ind Management Parameters for 10 Mb/s Operation and Associated Power Delivery over a Single Balance

tx_symb_triplet{TAn, TBn, TCn}

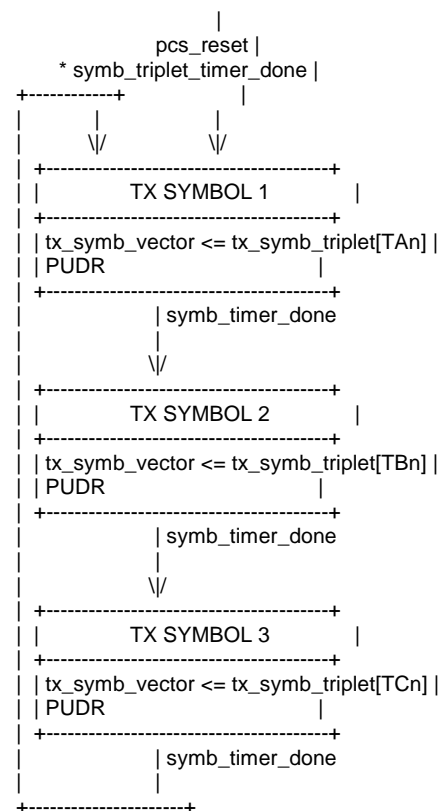
I think the problem is that there is another function within the PCS Transmit function that is missing from the PCS Transmit state diagram in Figure 146-5, the 'multiplexor' shown in Figure 146-6 'PCS transmit symbol generation'. This 'multiplexor' function operates at the symbol clock rate and serialises the tx_symb_triplet code-groups output by the PCS Transmit state diagram into individual symbols.

This may also explain when subclause 146.3.3.1.3 'Timers' defines the symb_timer that is not used in the PCS Transmit state diagram in Figure 146-5.

[4] Add a new subclause 146.3.3.2.2 titled 'Timers'. Move the symb_timer definition from subclause 146.3.3.1.3 Timers to this new subclause.

[5] Add a new subclause 146.3.3.2.4 'Abbreviations' that reads:

[6] Insert a new Figure 145-6 shown below (view using a non-proportional font such as courier), renumbering the following figures as required.

[7] Add text to subclause 146.3.3 'PCS Transmit' that reads 'The PCS Transmit function shall conform to the PCS Transmit state diagram in in Figure 146-5 and the PCS Transmit multiplexor state diagram in 146-6, and their associated state variables, functions, timers, and messages.'
